ADDENDUM NUMBER 1

PROJECT	BIDS DUE
Village of Central Lake Sanitary Sewer Improvements Division B – Pump Station Replacement GFA Project No: 21006	Date: August 27, 2026 Time: 9:30 AM Location: Village of Central Lake 2530 N Main St Central Lake, MI 49622

SCALE: NOT TO SCALE

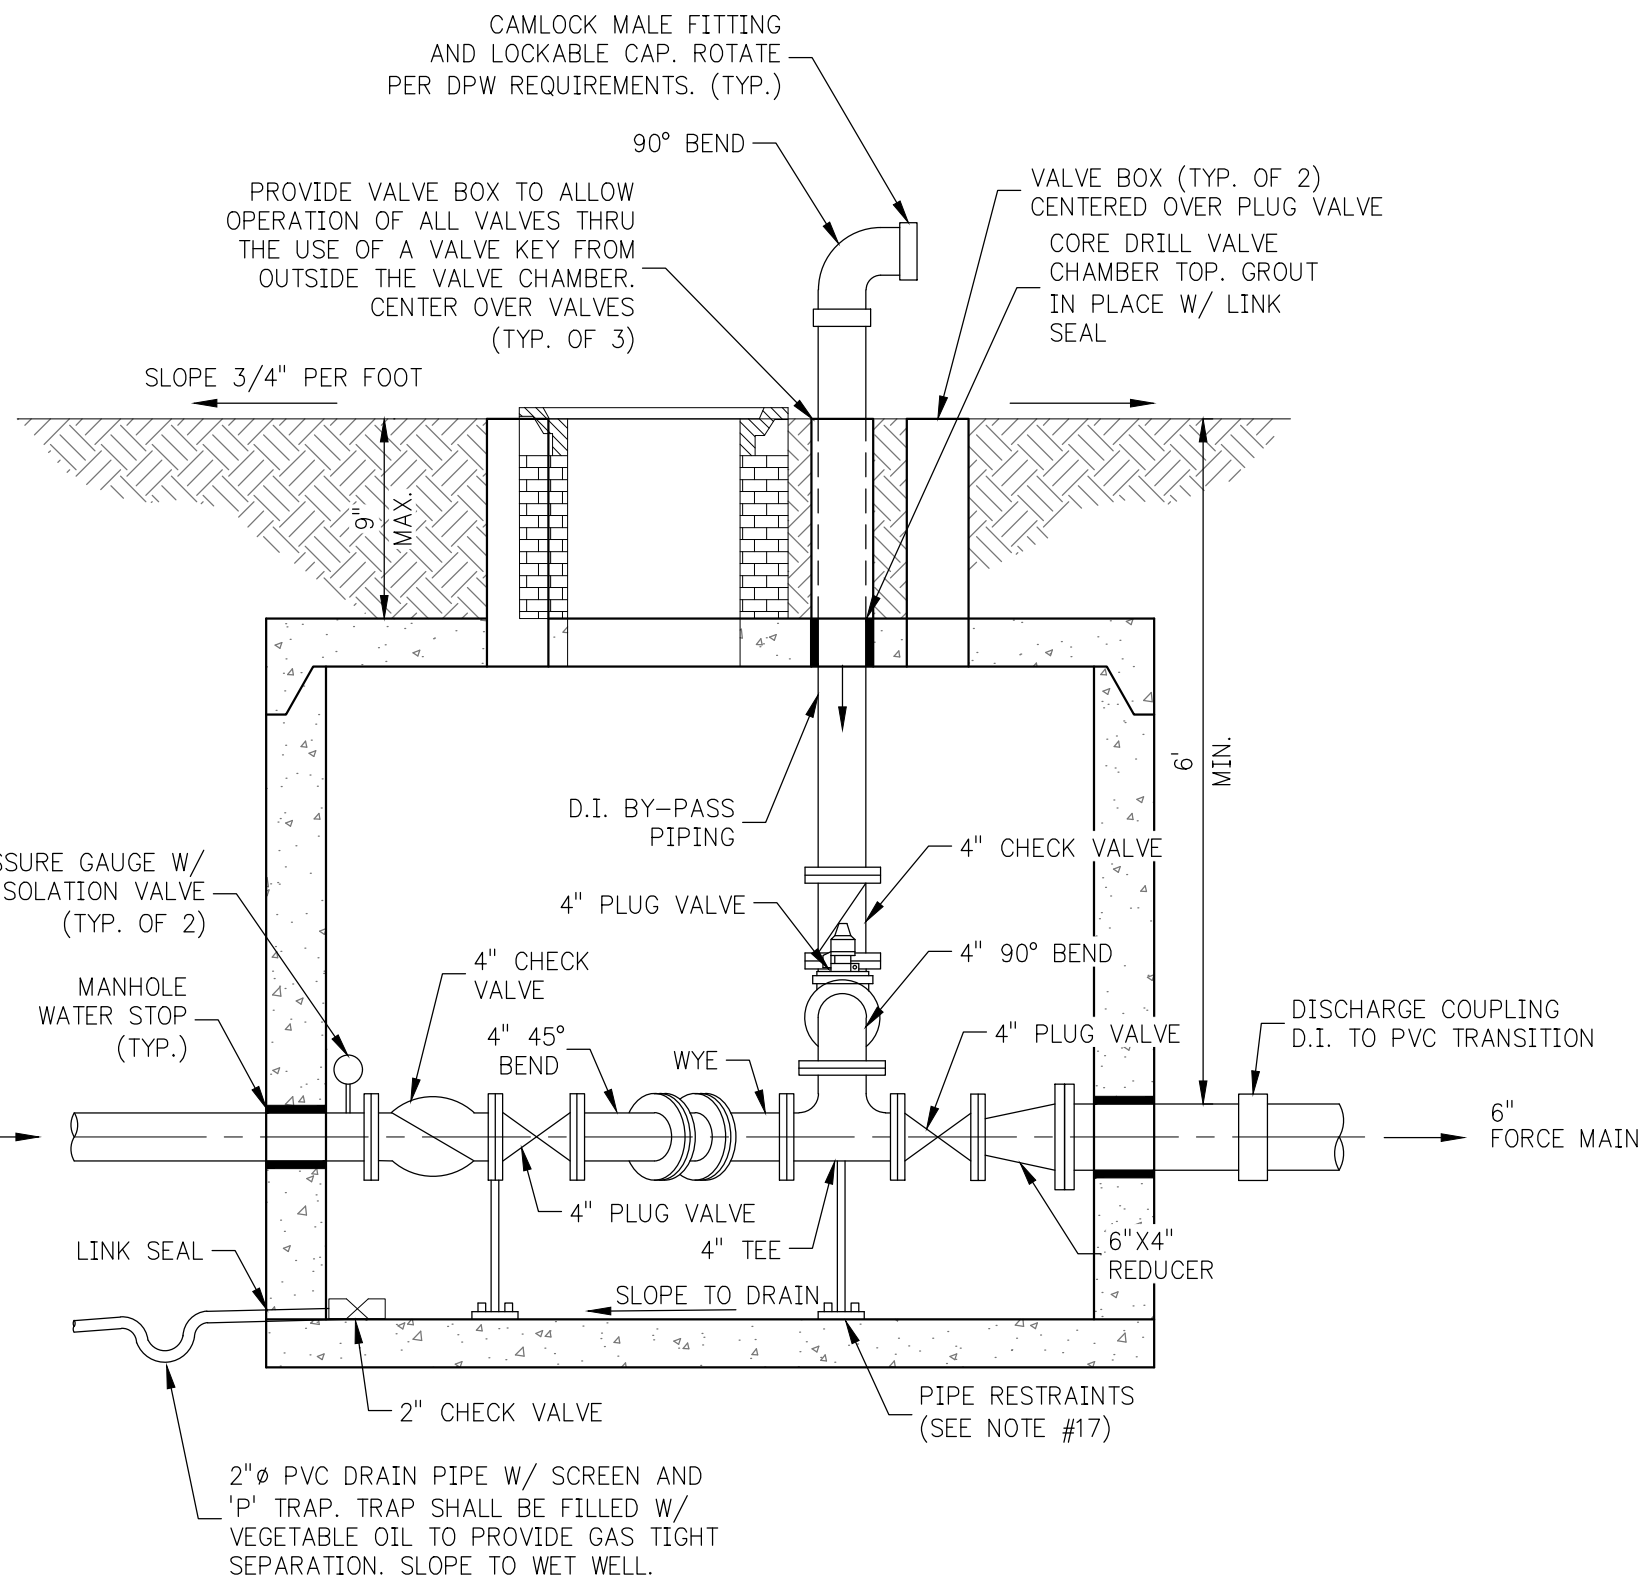
3. Sheet C4.2 shall be stricken in its' entirety and shall be replaced with the attached and incorporated into the bid documents. The proposed changes are clouded and provide additional wiring and conduit information pertinent to the proposed generator. In addition, further clarification and information is provided as the proposed generator is intended to support both Pump Station #1 and the Village Office. All costs associated with materials, electrical, wiring, conduit, and labor are to be provided and included in the respective bid items.
